## URGENT FIELD SAFETY NOTICE / PRODUCT NOTIFICATION

**Subject:** ExacTrac Dynamic Radiation Therapy Patient Positioning System:  
 For high dose treatments, potential patient movement might be displayed to the user with a delay

**Product Reference:** ExacTrac Dynamic versions 1.0.0, 1.0.1, 1.0.2

**Date of Notification:** April 29, 2021 (Update to the Notification of September 08, 2020)

**Figure 1: Patient Monitoring page: Red boxes indicate graphs that are potentially updated with delay. The displayed status may not correspond to the actual situation.**

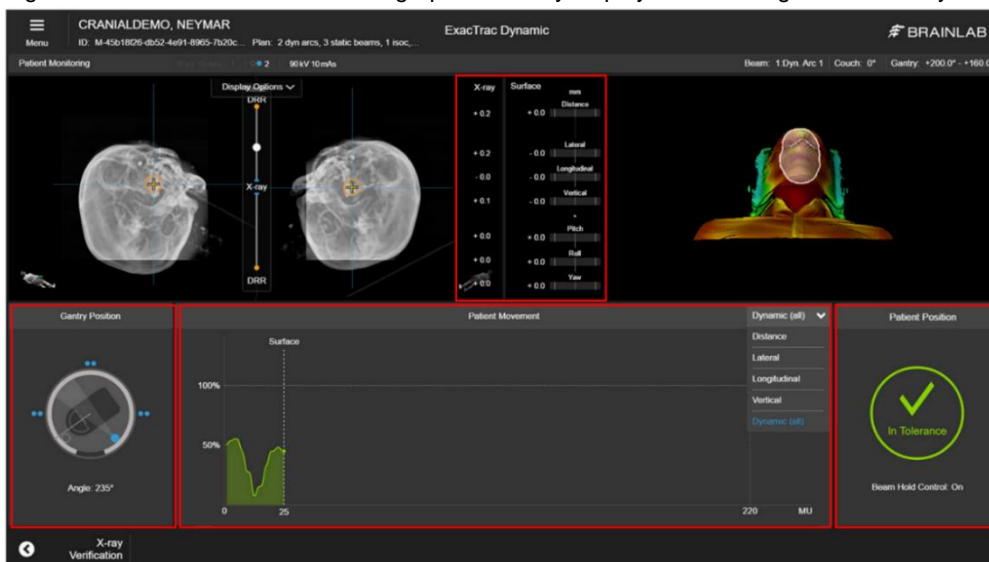
Brainlab determined that for high dose treatments, the update of the displayed information in several graphs may be delayed. However, the information itself is correct. Please refer to Figure 1: The red boxes indicate the graphs that may display status changes with a delay.

In the rare scenario in which a user relies solely on the information displayed by the Patient Monitoring page, the delayed update of information may lead to a delay in the user detecting the patient movement.

One anomaly contained in ExacTrac Dynamic software version 1.0.0 (as communicated on Sep 8, 2020) had been solved by improving the plotting routine of the Patient Movement graph. Only later an additional anomaly was identified that also contributes to the effect described: Due to an issue with the memory management of ExacTrac Dynamic, an undesired accumulation of memory (memory leak) may occur when plotting Patient Movement graphs containing many data points. The increasing memory consumption may accumulate across beams and even across patient treatments. The memory leak decreases performance of ExacTrac Dynamic and therefore compromises the software's ability to plot the Patient Movement graph in real time. As a result, the graph shows the patient position with an increasing delay that may reach several minutes. This further leads to other elements of the user interface being updated with that same delay (see Figure 1 for affected elements) and delayed button response to user interactions. In extreme cases, it may even lead to unresponsiveness of the ExacTrac Dynamic software.

Whether the issue occurs and to which extent depends on the total amount of delivered Monitor Units (MUs) exceeding a critical threshold of 2500 MU per beam/arc that have accumulated since the ExacTrac Dynamic software was last started.

- The critical threshold of 2500 MU per beam/arc was exceeded one or several times since the last start of the ExacTrac Dynamic software
- The patient has moved outside the defined tolerances
- The Beam Hold Control functionality is disabled, or the Beam Hold Control functionality is enabled and the user actively selects to ignore the beam hold

- 1) During treatment planning, ensure that the planned dose per beam/arc is **always below 2500 MU** when using ExacTrac Dynamic versions 1.0.1/1.0.2. You can do so by splitting beams/arcs, if required.  
(Please note that in the Notification of Sep 8, 2020, the values given when using Elekta Linear Accelerators were set too high at 3650 MU.)
- 2) Always keep the Beam Hold Control functionality enabled. If the system holds the beam, do not select "Ignore", but verify the patient position.
- 3) Restart the ExacTrac Dynamic software at least once a day, e.g., at the end of the treatment day, to clear potentially accumulated memory.

1. Existing customers that are potentially affected receive this product notification information.
2. Brainlab will provide a software revision of ExacTrac Dynamic with the described issue corrected to all affected customers. Brainlab will actively contact you to schedule the update, starting June 2021.

**Figure 1: Patient Monitoring page: Red boxes indicate graphs that are potentially updated with delay. The displayed status may not correspond to the actual situation.**

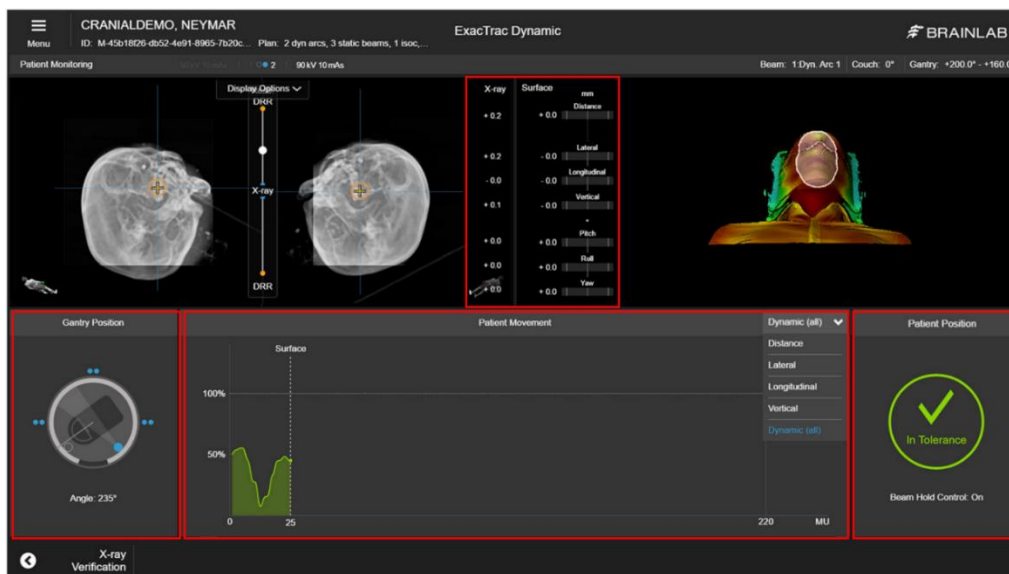
Brainlab determined that for high dose treatments, the update of the displayed information in several graphs may be delayed. However, the information itself is correct. Please refer to Figure 1: The red boxes indicate the graphs that may display status changes with a delay.

The delayed update of displayed information on the Patient Monitoring page is caused by a delayed update of the Patient Movement graph (see Figure 1, in the bottom middle), which plots the patient position deviation versus the delivered dose. This graph is redrawn entirely for each update of the plot. Hence, the time for drawing increases with the number of points in the graph. Since the delivered dose is transmitted from the Linear Accelerator to the ExacTrac system with a high update rate, it may happen that the plotting of the graph is still ongoing when the next update of delivered dose count is received from the Linear Accelerator. As a result, the graph no longer shows the patient position in real time, but rather with an increasing delay that may reach several minutes for high dose treatments. This further leads to other graphs being updated with that same delay (see Figure 1 for affected graphs) and delayed button reactions to user interactions.

- The planned dose per beam/arc is:
  - o larger than 1750 MU when using Varian Linear Accelerators
  - o larger than 3650 MU when using Elekta Linear Accelerators
- The patient has moved outside the defined tolerances
- The Automatic Beam Hold functionality is disabled, or the Automatic Beam Hold functionality is enabled and the user actively selects to ignore the beam hold.

- 1) During treatment planning, ensure that the planned dose per beam/arc is:
  - below 1750 MU when using Varian Linear Accelerators
  - below 3650 MU when using Elekta Linear AcceleratorsYou can do so by splitting beams/arcs, if required.
- 2) Always keep the Automatic Beam Hold functionality enabled, as is the default setting. If the system holds the beam, do not select "Ignore", but verify the patient position.

1. Existing customers that are potentially affected receive this product notification information.
2. Brainlab will provide a software revision of ExacTrac Dynamic with the described issue corrected to all affected customers. Brainlab will actively contact you to schedule the update, starting October 2020.
